[Docket No. FAA-2021-0872; Project Identifier MCAI-2021-00312-R; Amendment 39-21866; AD 2021-26-07]

Airworthiness Directives; Airbus Helicopters

ACTION: Final rule.

2021-26-07 Airbus Helicopters: Amendment 39-21866; Docket No. FAA-2021-0872; Project Identifier MCAI-2021-00312-R.

Figure 2 to paragraph (g)(1)(ii) – Inspection Areas of Tail Rotor Splined Flange

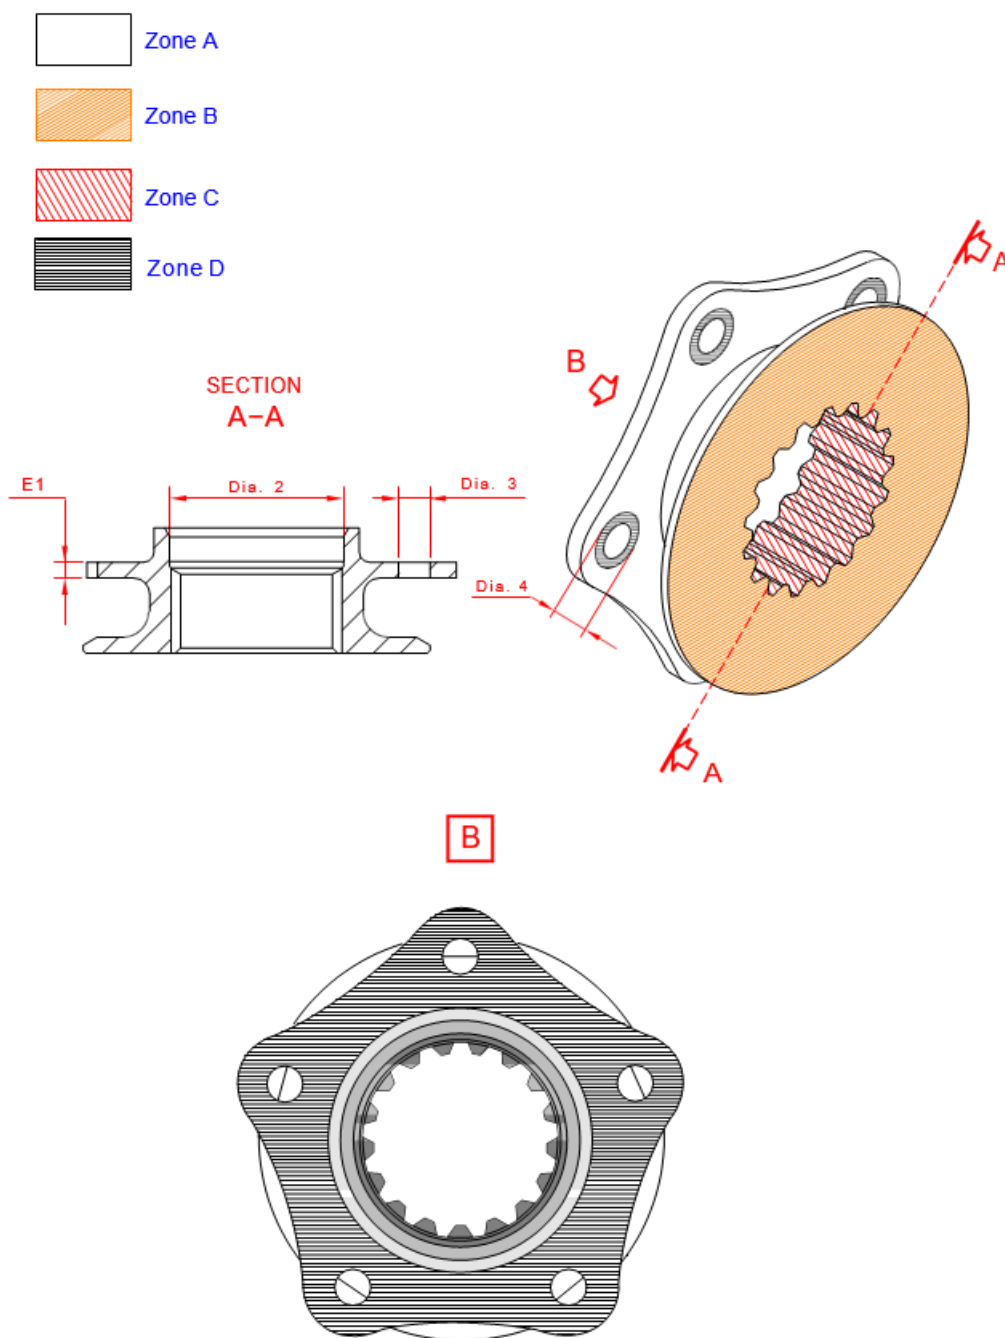
(ii) Inspect the TR splined flange for corrosion, impacts, fretting, wear, and a crack in the areas identified in Figure 2 to paragraph (g)(1)(ii) of this AD. If the condition of the part (including corrosion, impacts, fretting, wear, or cracks) exceeds the criteria as specified in Figure 1 to paragraph (g)(1)(ii) of this AD, before further flight, remove the splined flange from service and replace with an airworthy part.

Location as specified in Figure 2 to paragraph (g)(1)(ii) of this AD	Maximum damage, which causes replacement (E1, Dia. 2, Dia. 3, and Dia. 4 are shown in Figure 2 to paragraph (g)(1)(ii) of this AD)
Zone A	Scratch depth > 0.2 mm (0.008 in.). Crack. E1 < 2.75 mm (0.108 in.). Dia. 3 > 6.02 mm (0.2371 in.). Dia. 2 > 33.03 mm (1.3004 in.).
Zone B	Touch-up depth > 0.1 mm (0.004 in.). Crack.
Zone C	Crack. Scratch depth > 0.2 mm (0.008 in.).
Zone D [Dia. 4 = 14 mm +/- 0.1 mm (0.548; 0.555in.)]	Touch-up depth > 0.1 mm (0.004 in.). Crack. E1 < 2.75 mm (0.108 in.).
